UNITED STATES PATENT AND TRADEMARK OFFICE

| APPLICATION NO. | FILING DATE | FIRST NAMED INVENTOR | ATTORNEY DOCKET NO. | CONFIRMATION NO. |
|--|-------------|-----------------------|---------------------|------------------|
| 10/530,635 | 10/28/2005 | George C Konstantakis | 550637.90018 | 7503 |

| Office Action Summary | Application No. | Applicant(s) | |

DETAILED ACTION

attachment #1

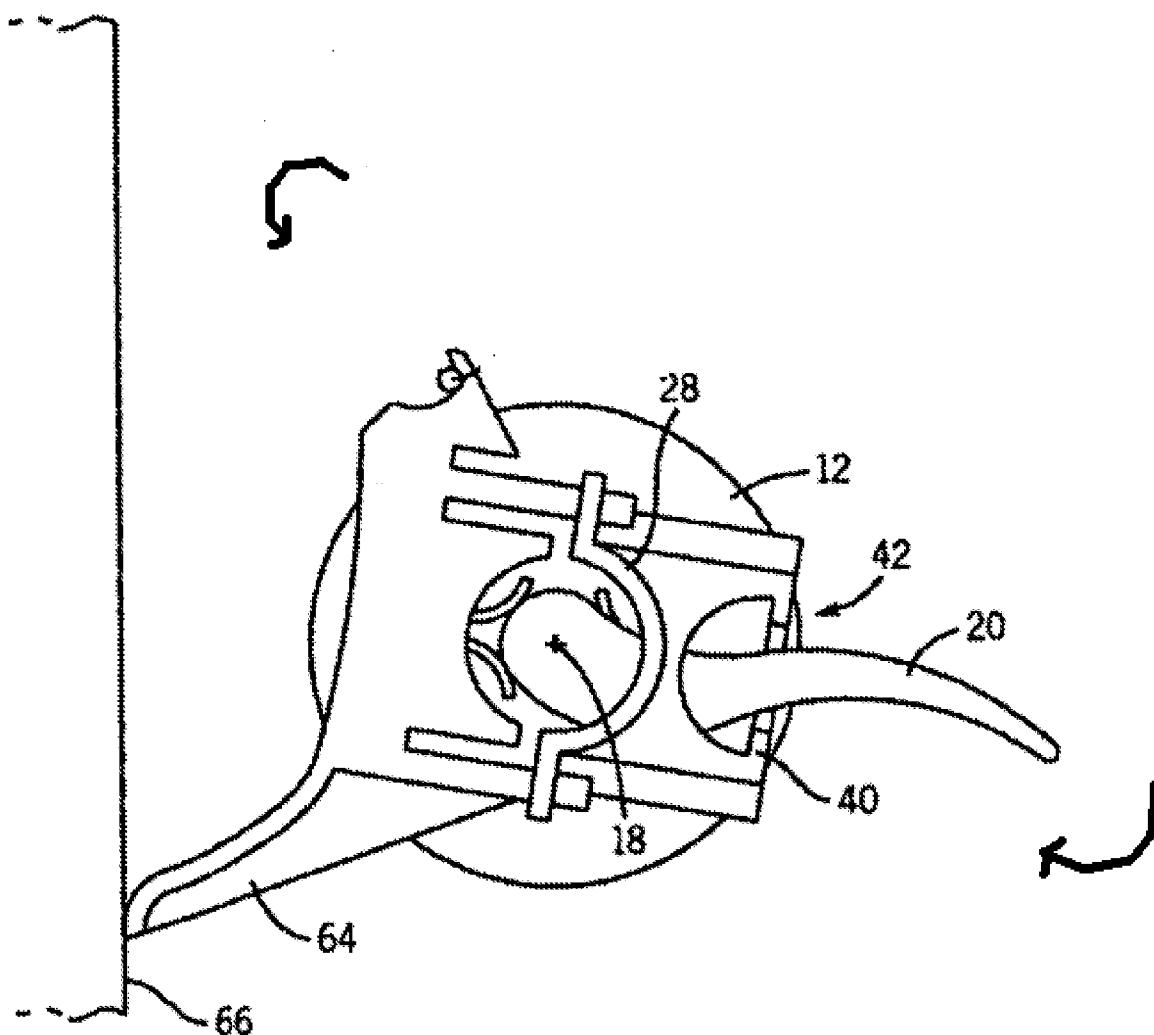
Claim 1 recites that the child safety lock comprises at least one connecting element. However, it is unclear of how the safety lock would work with only one connecting element.

The claim language requires that the lever is prevented from any rotation when the connecting element contacts the stationary element.

In the event of having a lever that rotates in only one direction, it would only require just one connecting element, which will prevent the rotation of the lever in that direction.

In the event of having a lever that rotates in both directions, the device requires two connecting elements. If the device has only one connecting element, then is not capable of preventing rotation of the lever, as seen in attachment #1, since it would rotate in the other direction.

Therefore, the rejection is maintained until the applicant CLEARLY describes the invention. Appropriate correction is required.
